Agenda Item 3

PLANNING REVIEW COMMITTEE 15th March 2017

Application Numbers: 16/02507/CND for route section H

Proposal: Details submitted in compliance with condition 19 item 2

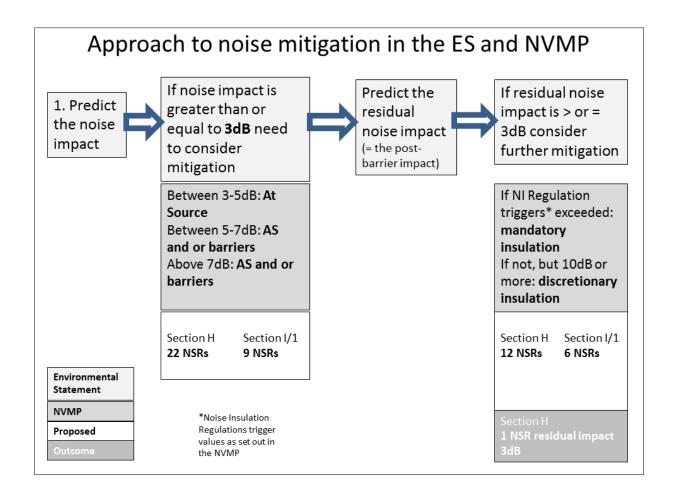
- 9. This is a very complex technical area. To assist the Committee, the diagram below summarises the decision making sequence which has been applied to determine the necessary mitigation of noise impacts in the two NSoAs. In the diagram, ES = Environmental Statement; NVMP = Noise and Vibration Mitigation Policy which was approved by the Secretary of State as part of the deemed permission.
- 10. The outcome (bottom right hand box) of all the mitigation applied (barriers and insulation) is that all significant noise impacts are mitigated apart from at one Noise Sensitive Receptor (NSR), a property in section H where there is a residual (post barrier) impact of 3dB.
